SERVICE PROCEDURE

19501
April, 2019

SUBJECT: SAFETY RECALL
Exhaust Hanger Bracket in certain 2016 thru 2020 International® LT® Series trucks built 15 December 2015 thru 08 February 2019 and certain 2017 and 2018 ProStar® model trucks built 02 March 2016 thru 12 June 2017 with 73-inch sleeper cab and feature code 07BKP or 07BKR (exhaust system with horizontal aftertreatment devise and horizontal tailpipe mounted on right-side).

Figure 2. Exhaust System

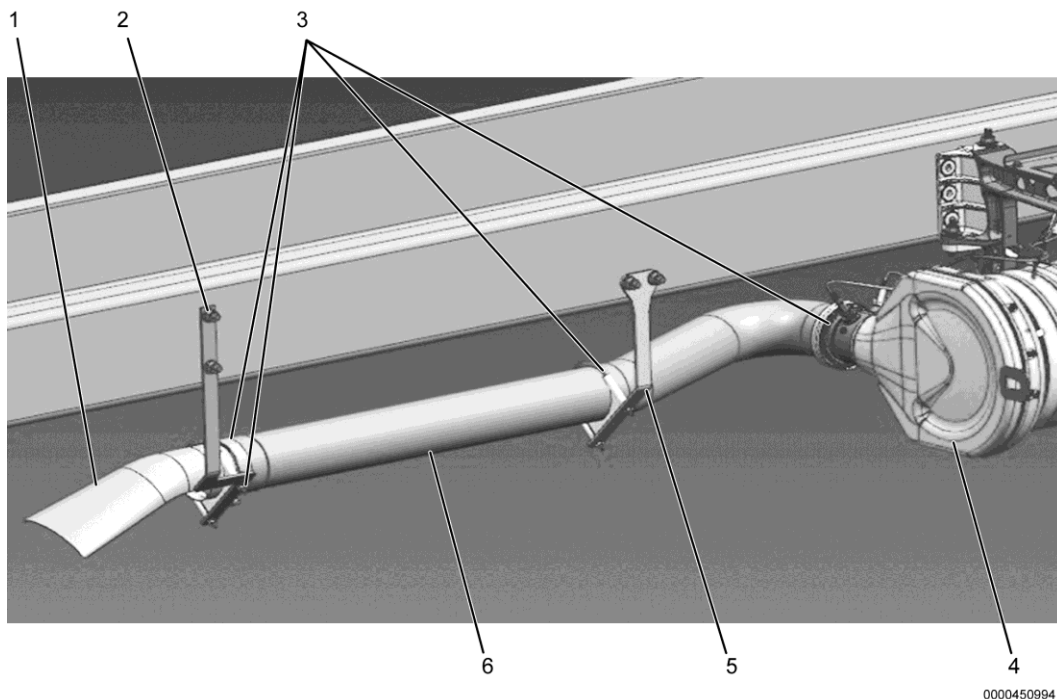
The rear exhaust hanger bracket may crack and, over time, may cause the forward hanger bracket to crack and in some cases may result in partial or full separation of the exhaust tail pipe from the vehicle. If the exhaust tail pipe separates from the vehicle in operation, a loose part in the roadway could be struck by another vehicle which increases the risk of a vehicle crash.

5. Inspect exhaust tailpipe (Figure 2, Item 6) at Diesel Particulate Filter (DPF) (Figure 2, Item 4) for cracks.
 - a. If exhaust tailpipe has no cracks, proceed to Step 10.
 - b. If exhaust tailpipe has cracks, continue with Step 6.
6. Disconnect exhaust tailpipe from DPF and from rear hanger bracket (Figure 2, Item 2) and forward hanger bracket (Figure 2, Item 5). Save DPF clamp and clamp used at forward hanger bracket for reuse.
7. Remove diffuser (Figure 2, Item 1) from exhaust tailpipe. Save diffuser and clamp (Figure 2, Item 3) for reuse.

NOTE: Tighten Marmon clamp to 89 - 133 lb-in (10 - 15 N•m). Tighten band clamp to 41 - 46 lb-ft (55 - 63 N•m).

8. Using Marmon clamp or band clamp (Figure 2, Item 3), install diffuser (Figure 2, Item 1) onto new exhaust tailpipe (Figure 2, Item 4). Tighten Marmon clamp or band clamp to their specified torque.

9. Install new exhaust tailpipe (Figure 2, Item 6) onto DPF (Figure 2, Item 4). Do not tighten clamp at DPF (Figure 2, Item 3) at this time.
10. Remove rear hanger bracket (Figure 2, Item 2) from frame and save fasteners for reuse.

11. Remove clamp (Figure 2, Item 3) and rear hanger bracket (Figure 2, Item 2) at diffuser (Figure 1, Item 1) and discard.
12. Install new rear hanger bracket (Figure 2, Item 2) to frame. Tighten fasteners to 148 lb-ft (200 N.m).

13. Install new clamp (Figure 2, Item 3) and rear hanger bracket (Figure 2, Item 2) at diffuser (Figure 1, Item 1). Do not tighten clamp at this time.
14. Inspect forward hanger bracket (Figure 2, Item 5) for cracks.

- a. If bracket has no cracks, proceed to Step 19.
 - b. If bracket has cracks, continue with Step 15.
15. Remove forward hanger bracket (Figure 2, Item 5) from frame and save fasteners for reuse.

17. Install new forward hanger bracket (Figure 2, Item 5) to frame. Tighten fasteners to 148 lb-ft (200 N•m).
18. Reinstall clamp (Figure 2, Item 3) around exhaust tailpipe at forward hanger bracket (Figure 2, Item 5). Do not tighten clamp at this time.
19. Tighten clamps (Figure 2, Item 3) at forward hanger bracket (Figure 2, Item 5) and rear hanger bracket (Figure 2, Item 2). Tighten both clamps to 195 - 247 lb-in (22 - 28 N•m).
20. If pipe was replaced, tighten clamp at DPF (Figure 2, Item 3) to 89 – 133 lb-in (10 - 15 N•m).
21. Remove wheel chocks.
